204-11

V8 XJ Series/XK8

MODEL:
1997 MY-ON XK8 Range
1998 MY-ON V8 XJ Series
VIN:
001001-ON
812256-ON

Revised Front Bushings - Revised Special Tools - Replacement Procedure

ILLUSTRATION 1

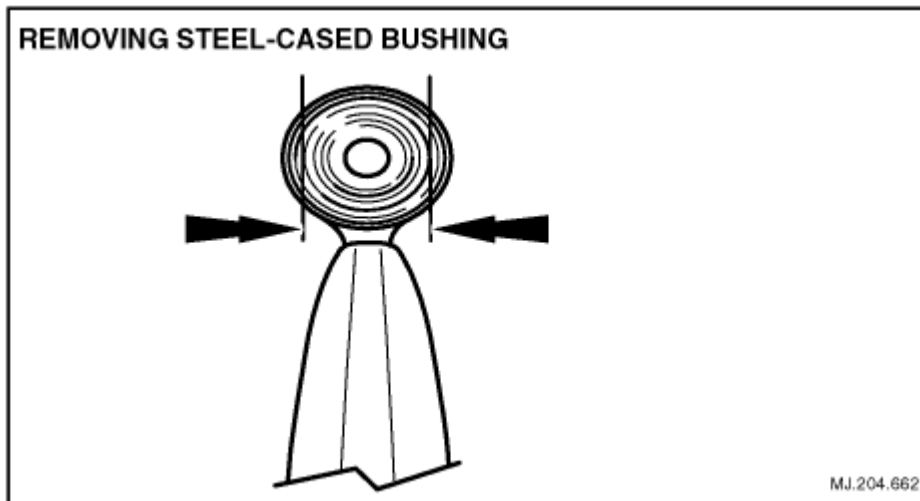
1. Make 2 saw cuts through the rubber and **partly** into the flange of the steel casing, at the locations shown in Illustration 1, in line with the casing of the bush.

Caution: Do **not** cut **fully** through the steel flange. The saw cuts should penetrate through only 75 - 80 % of the thickness of the steel flange, so that the wishbone arm is **not** touched by the saw blade.

ILLUSTRATION 2

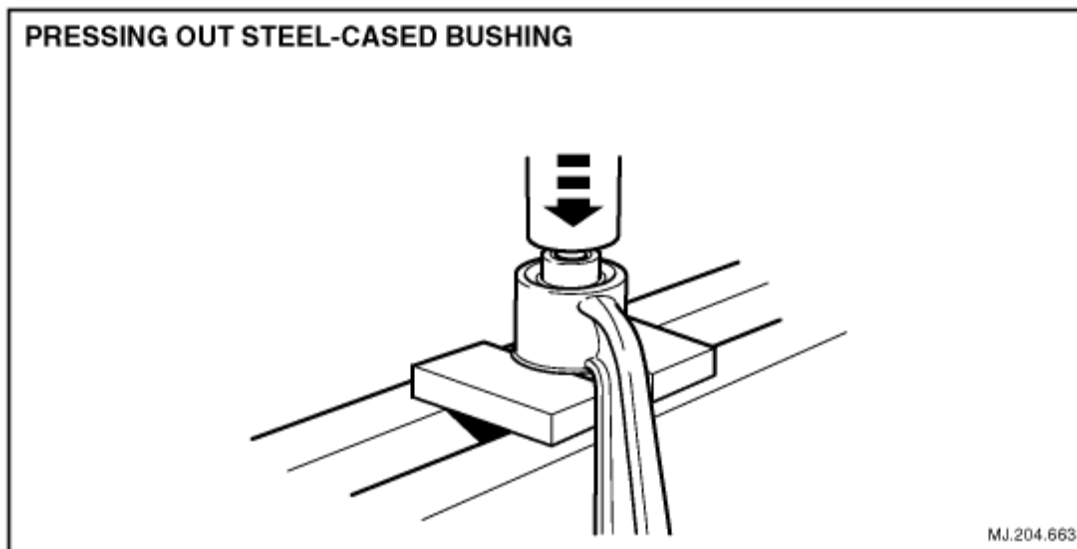
3. position the wishbone arm on the support plates of the hydraulic press, so that the bushed end is supported by the plates where the "half-moons" have been removed, allowing the casing of the displaced bush to pass between the support plates. See Illustration 2. (Front arm illustrated - rear arm similar).
